December 10, 2025

**Re: DRAFT Letter - Pedestrian Wind Assessment  
3115 Hurontario Street  
RWDI Reference No. 2406897**

**Image 2: 3D Model of the Updated Design of the Proposed Development**

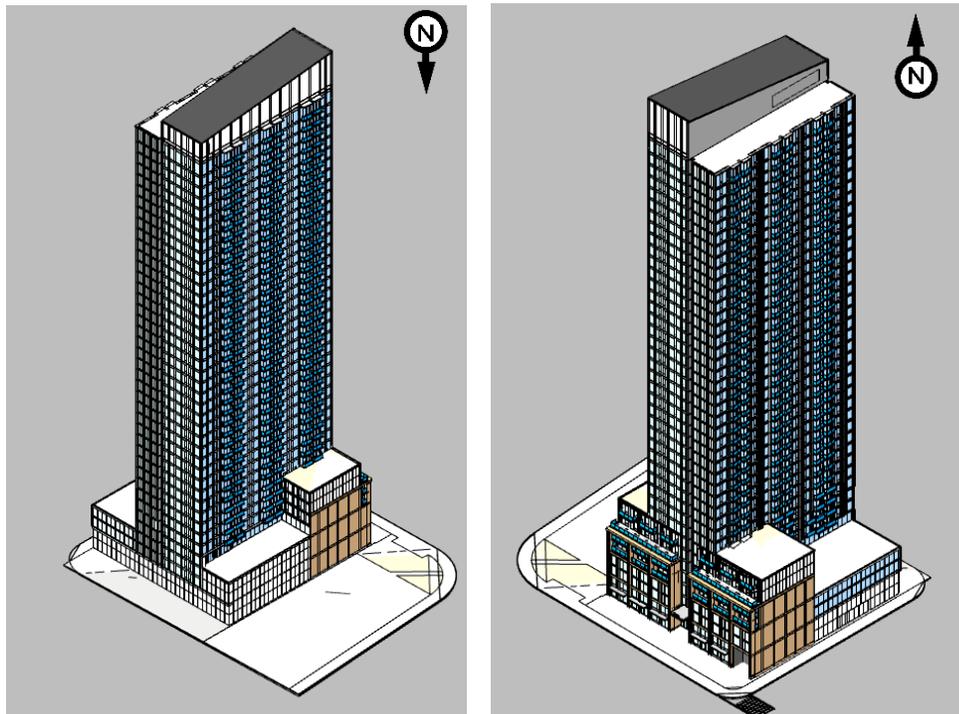
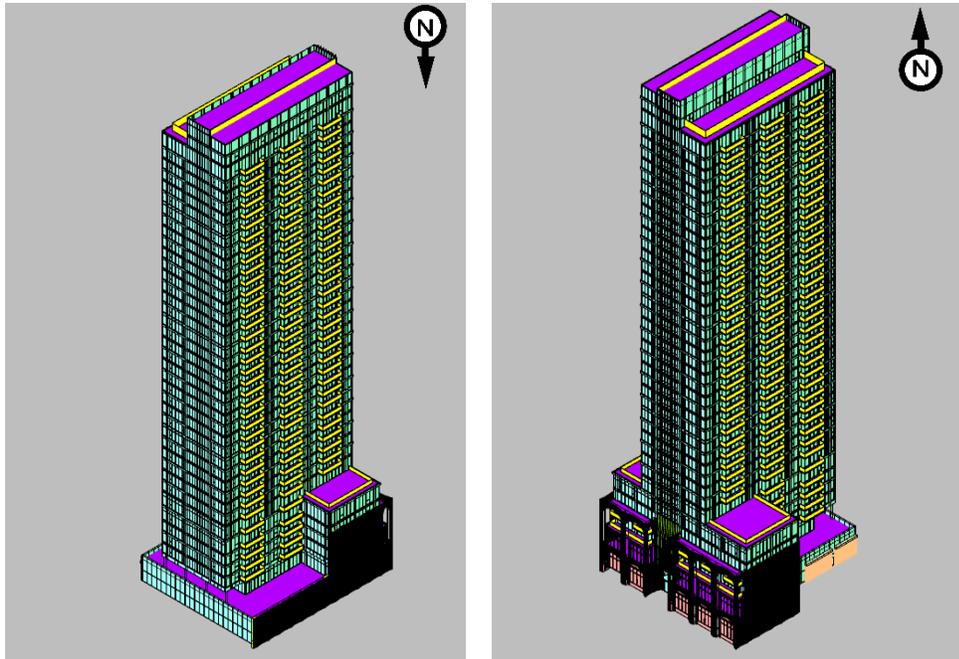
Following the wind study, RWDI received an updated 3D model on July 23, 2025 (Image 2). Major design changes that may potentially affect the predicted wind conditions include:

- The reduction of the podium height on the north side of the building by 1 storey; hence, the outdoor amenity areas were moved from Level 3 to Level 2.
- The introduction of approximately 6 m setbacks on the east side of the building at grade, and on the north side of the podium at Level 2.
- The addition of an outdoor amenity space on the east side of the tower on Level 40, which is enclosed by a 2 m parapet.

Since the overall design, height, and orientation of the proposed development have not changed significantly relative to the design studied previously, similar wind conditions to those presented in the March 4, 2025 report are expected with the new design. The downwashing off the towers' façades and the subsequent corner acceleration flows associated with the latest design of the project are expected to occur in a similar manner to that of the initial design. The 6 m setbacks on the north and east sides are considered significant design changes. While the setback on the east side of the building is not expected to change wind conditions significantly since the prevailing winds are from westerly and northwesterly directions, the setback on the north side is expected to improve the wind conditions north of the proposed building. However, its impact on the areas south of the proposed building is expected to be minimal. Generally, the areas with exceeding wind conditions along Hurontario Street, as indicated in the March 4, 2025, report, are expected to remain unchanged with the new design.

The wind conditions on the Level 2 outdoor amenity area are expected to be similar to those at Level 3 in the prior study. The rooftop terrace will be located on the east side and sheltered by the roof structure from the prevailing westerly and northwesterly winds. The terrace is also enclosed by a 2 m tall parapet. Therefore, wind conditions at this level are expected to be generally appropriate for the intended use in the summer, when the outdoor spaces will be used most often. Slightly higher wind speeds might be experienced at the north and south ends, so we recommend increasing the parapet height to a minimum of 2.5 m to achieve calm wind speeds throughout the amenity space. The latest drawing, AZ208, has incorporated the recommended parapet height, and wind speeds throughout the amenity space are expected to meet the safety criteria.

**Image 3: Wind Pattern and Proposed Mitigation Strategies**

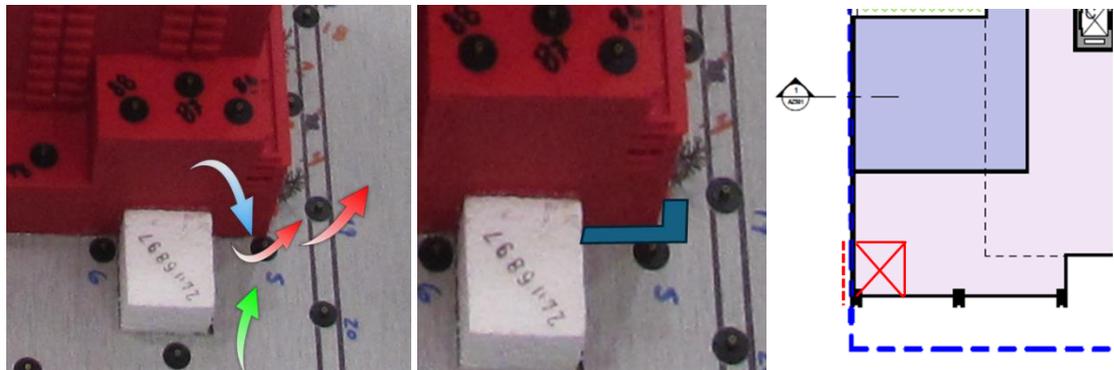
1. Sensor 18 – Southwest Building Corner
  - a. The marginally exceeded wind condition at this location is driven by corner accelerations resulting from the interaction of prevailing northwest winds with the building’s exposed west façade. These winds are deflected downward due to downwash effects, then redirected horizontally around the southwest corner, creating a zone of intensified flow. Secondary contributions from horizontal winds along Hurontario Street further amplify wind speeds in this area (Image 3).

- b. The predicted wind speed was 92 km/h, slightly above the 90 km/h threshold defined by the safety criterion. This is considered a borderline exceedance but still warrants mitigation due to potential pedestrian safety concerns.

- c. Recommended Mitigation Strategies (Image 3):
    - i. Incorporate wind-breaking elements such as coniferous trees, porous screens, or trellises near the southwest corner to disrupt acceleration zones.

- ii. If landscaping is not feasible, consider installing a continuous canopy or trellis along the west façade, wrapping around the southwest corner to intercept downwash flows.

- iii. Introducing a re-entrant corner at grade, combined with a porous screen, can reduce wind convergence and lower peak velocities.
  - d. The latest drawings, AZ204, have incorporated the recommended “iii.” wind mitigation measure. We only note that this windscreen should be at least 2 m high. Wind speeds at Sensor 18 are expected to meet the safety criteria.
